STP Post-meeting Notes for January 26-27, 2012 Public Meeting

Resolutions & Comments

Fig1. The schematic representation of PRA & CASA Grande in the STP Risk-Informed GSI-191 project

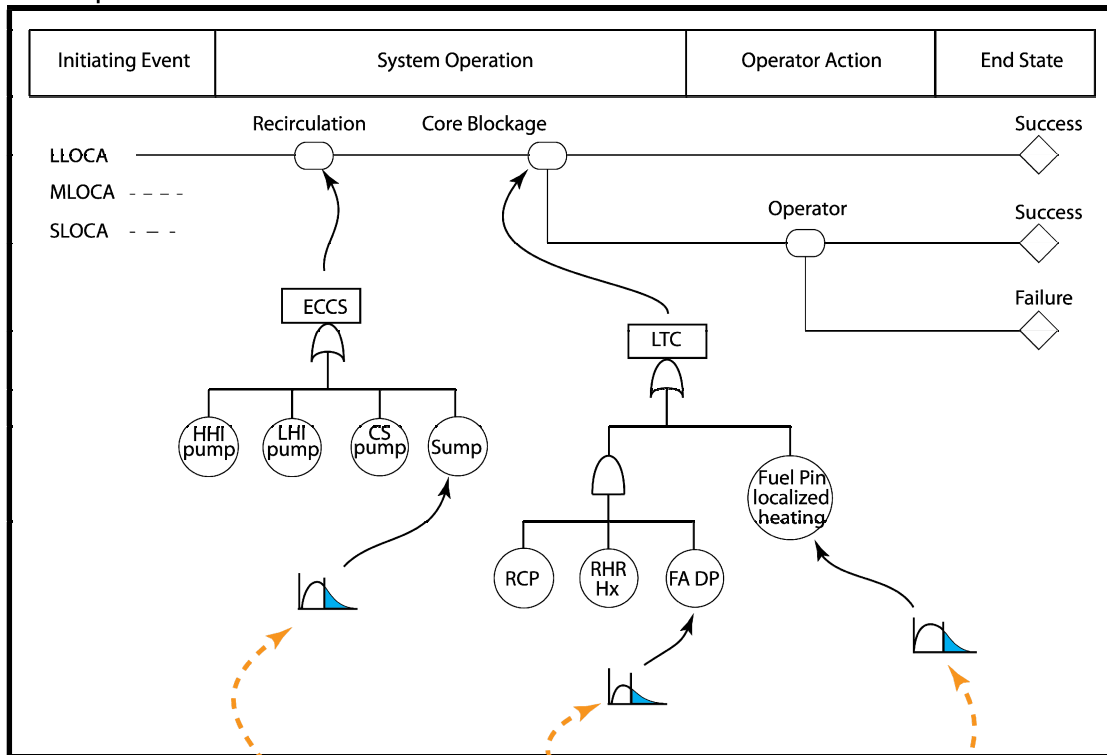
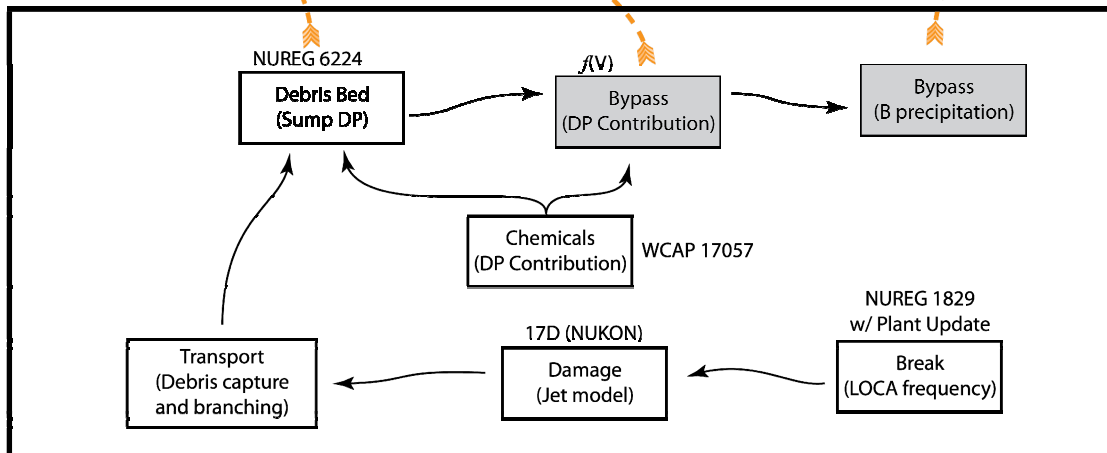
In view of this, the response to the question/comment about the cut sets in this project would be “we have the typical cut sets of Power Plant PRA”

And the response to the comment on CASA Grande being a black box is that “CASA Grande is **not** a black box but is, in fact, instrumental in opening the black boxes of two important events in the scenarios of a Power Plant PRA (i.e. recirculation and core blockage) by model-based estimations of the likelihood of their underlying basic events”.

Figure (1), on the next page, shows the schematic interrelationship of PRA and CASA Grande in the STP Risk-informed GSI-191 project. The figure does not attempt to cover all PRA scenarios (to avoid complexity with the figure). The main purpose is to present and to clarify the relationship between PRA and CASA Grande.

In the integrated model, developed in this project, PRA is located at the top level of system analysis. This plant-specific PRA has the typical Power Plant Fault Trees and Event Trees covering hardware failures and operators' actions and so, has the typical PRA **cut sets**.

One important aspect of this project is that CASA Grande provides estimates for the likelihood of three basic events of Fault Trees in PRA:

In other words, rather than relying solely on historical failure data for these three basic events (something that a typical PRA does), the STP risk-informed project develops the models (in CASA Grande) for the underlying chemical and mechanical phenomena which lead to the three basic events. The output of CASA Grande will give a more accurate estimate of the likelihood of these three basic events and can then be imported to Fault Trees of the plant-specific PRA in order to calculate CDF.
